Transnuclear Handouts – Part 3 of 6 - 10/07/09 Public Meeting  
(Draft RAI Responses – non-proprietary)

RAIs and Responses

Enclosure 2 to E-xxxxx

**Figure 2-8.1 – TN 40 Shell Flange, Nodal Stress Intensity Distribution for A12 (Cold)**

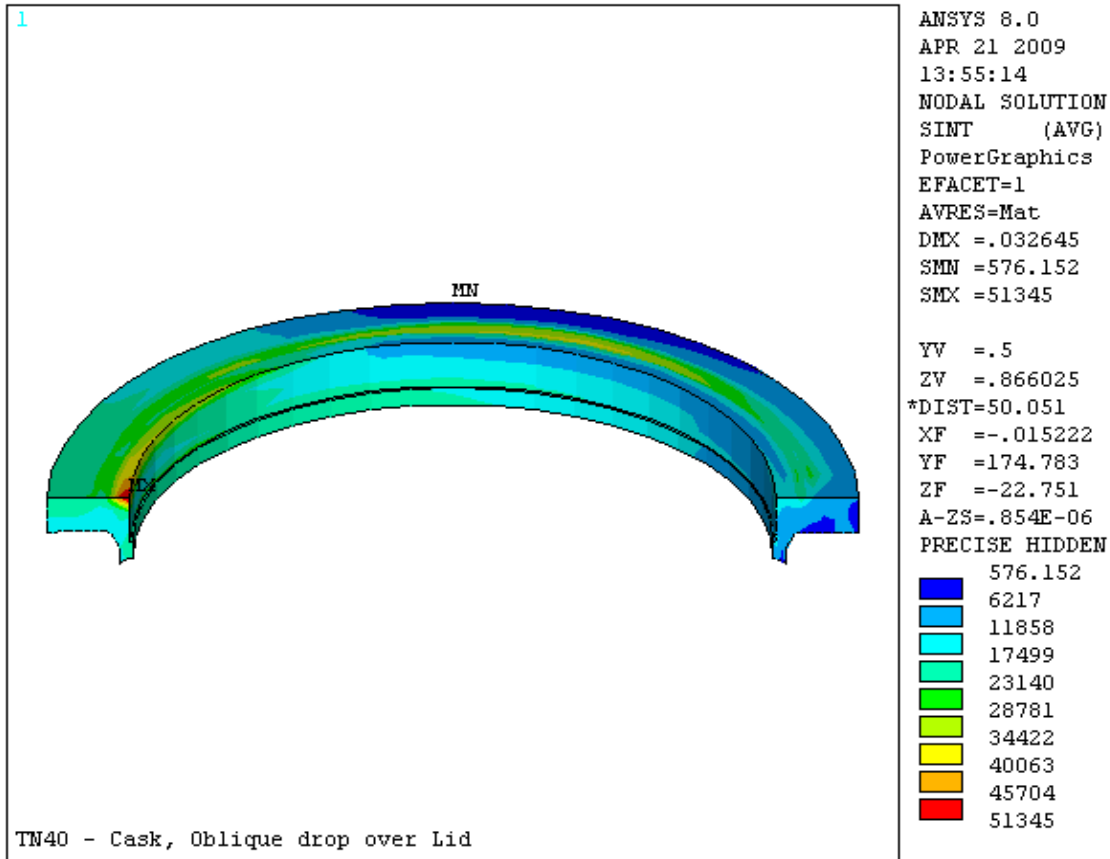
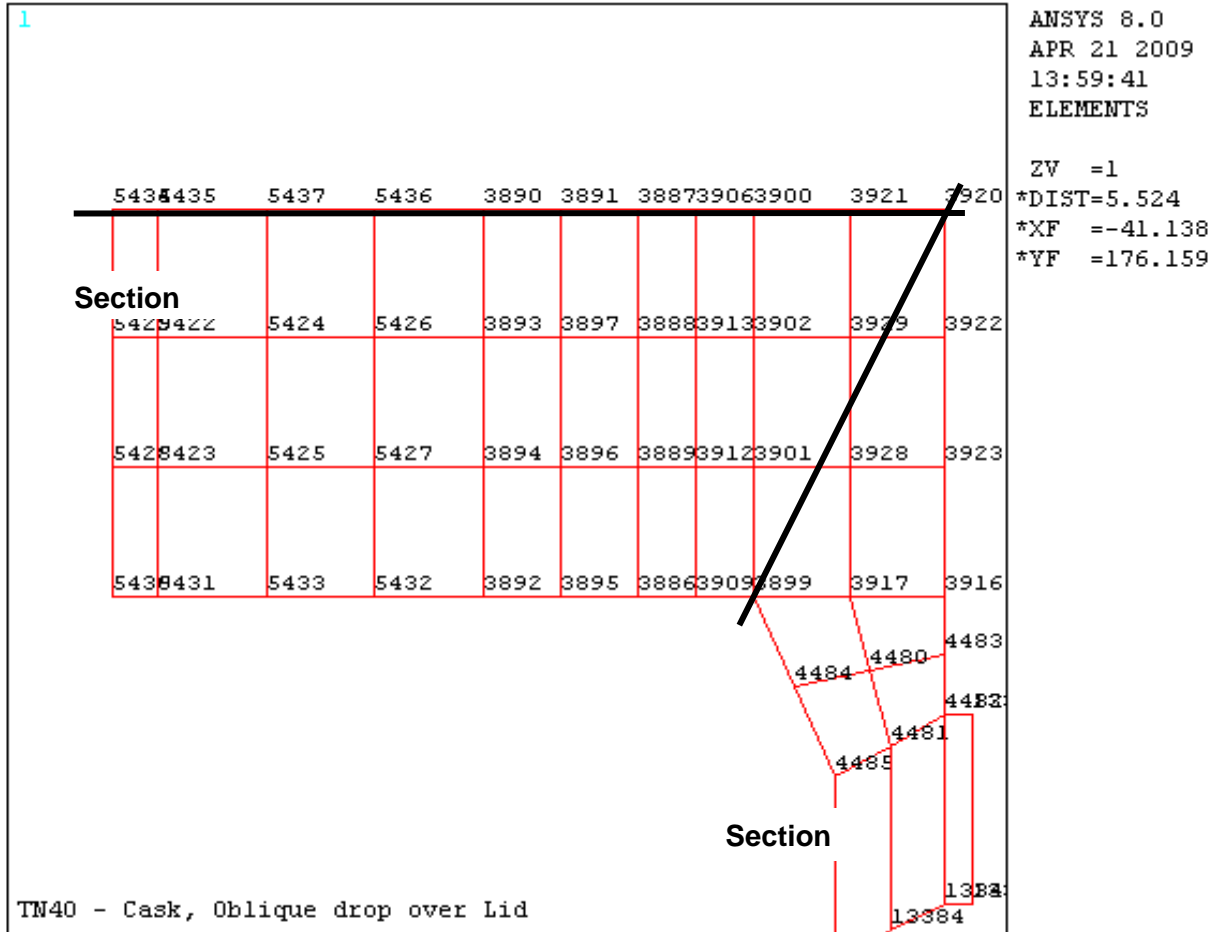
2-8 Verify that the cross section is appropriately selected for evaluating the maximum stress intensity for the containment boundary shell flange for the load combination Case A12, which includes the cold, 30-ft slapdown drop event.

*The nodal stress intensity distribution in the shell flange for load combination Case A12 is shown in Figure 2-8.1. This load combination includes the cold, 30-ft slapdown drop on lid event. It is seen that the maximum nodal stress intensity of 51.35 ksi occurs at node number 3920 located at flange inner diameter corner. Flange node numbers at a section through 3920 are shown in Figure 2-8.2. The two cross sections from the highest stress intensity node 3920 shown in Figure 2-8.2 are considered bounding. One cross section is defined by nodes No. 3920 and No. 5434 and other cross section is defined by nodes No. 3920 and No. 3899. Stresses are linearized at both the cross sections. The stress linearizing details at these two cross sections is given in Tables 2-8.1 and 2-8.2. A summary of stress intensities is given below:*

*It is seen from above that cross section 1, defined by nodes No. 3920 and No. 5434, has the higher stresses and was therefore appropriately selected for reporting shell flange stresses in SAR.*

Figure 2-9.1

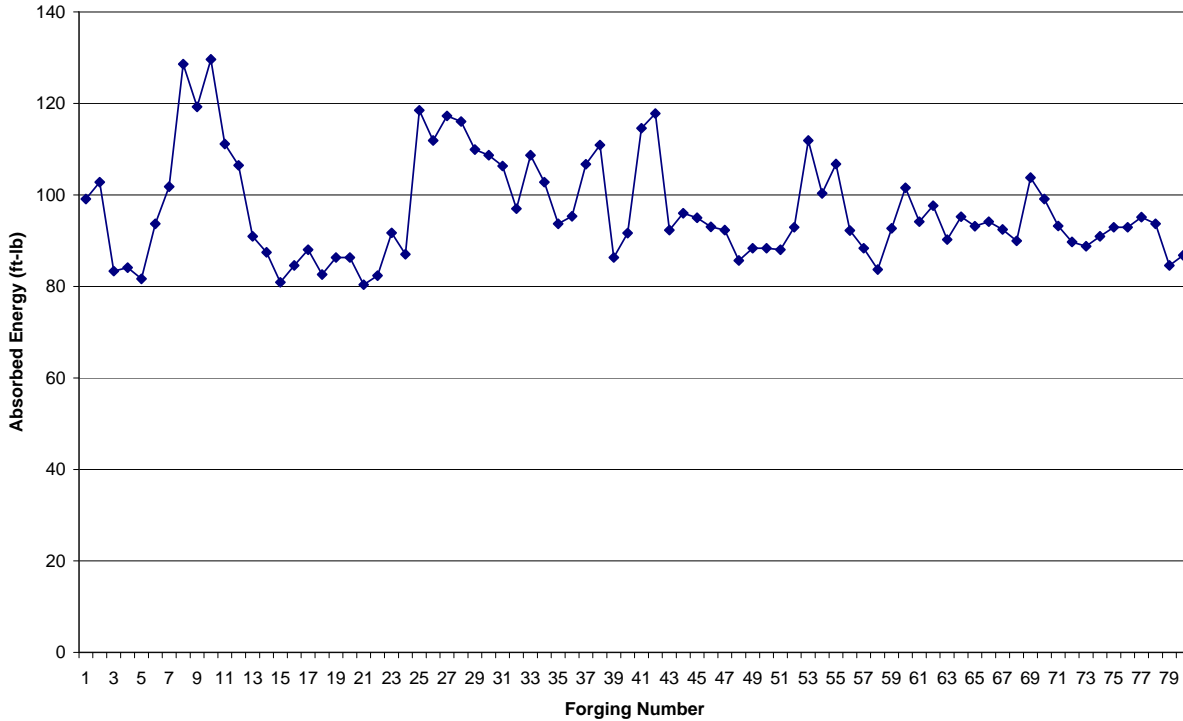
- 2-9 Provide justification that the testing, using a limited combination of potential base metals, filler materials, and weld techniques (2 tests), bounds the worst case fracture toughness expected from all potential combinations of these three parameters. Explain why TN fabricators chose the combination of weld processes, electrodes, and base material presented in the table to demonstrate the toughness of the weld and heat affected zone (HAZ). Defend why the table data are representative of all other possible combinations which can be used, or are these data the best case scenario?

For current procurement, each TN-68 Shield Shell is fabricated from two forgings. Fracture toughness test results (-20F Charpy V-notch testing) for forty forgings is available and shown in Figure 2-9.1.

The average test result for the forty TN-68 Shield Shells at -20°F was 96.6 ft-lb with a standard deviation of 11.3 ft-lb. The TN-68 results are both much higher (over five times) than the TN-40 requirement of 18 ft-lb and very consistent. 18 ft-lb equals the average TN-68 result minus nearly seven standard deviations. These results strongly support the conclusion that the fracture toughness properties of the TN-40 Shield Shells exceed the minimum required by a margin which can safely accommodate any realistic variations in chemical composition and physical processing as well as the effects of welding.

Heat-to-heat variation in stress-strain diagram for 304 stainless steel tested at (a) 24°C, (b) 93°C, (c) 204°C, and (d) 316°C.

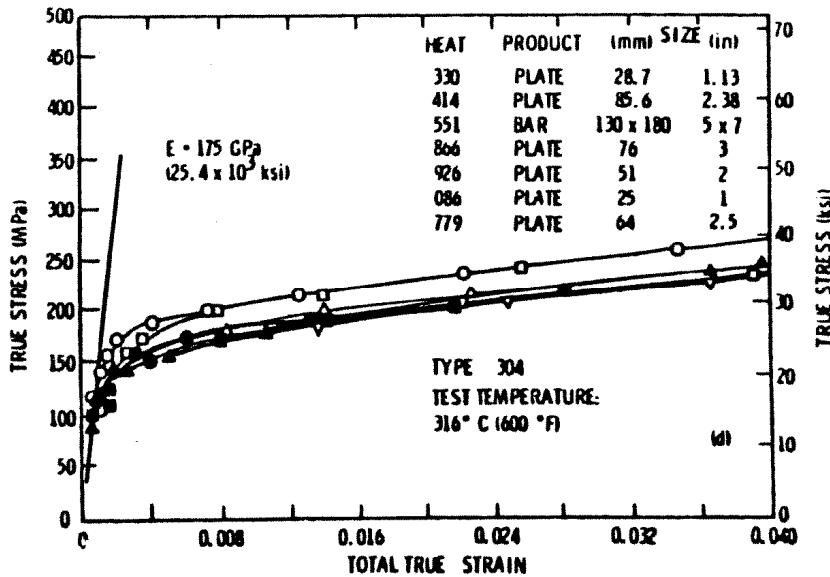
2-12 On page 2.10.5-4, provide data or reference to show that a 5% strain-hardening rate ( $E_p/E = 0.05$ ) is conservative for the bilinear stress-strain curve implemented for both the SA-240 Type 304 SS steel and SB-209 Type 6061-T651 aluminum alloy plates in the basket non-linear finite element structural analysis.

A figure with representative stress-strain curves for SA-240 Type 304 is shown below. The figure is taken from NUREG/CR 0481 [1]. This figure is used as a basis for the 5% strain-hardening rate shown in the bilinear stress-strain curve.

Using a 5% strain-hardening rate, which is greater than those shown in the figure above, is conservative because it will yield higher stresses. The maximum stress in the SS Boxes is less than 30 ksi (~201 MPa); thus the material remains in the low plastic strain region where the effect of the strain-hardening rate is minimal.
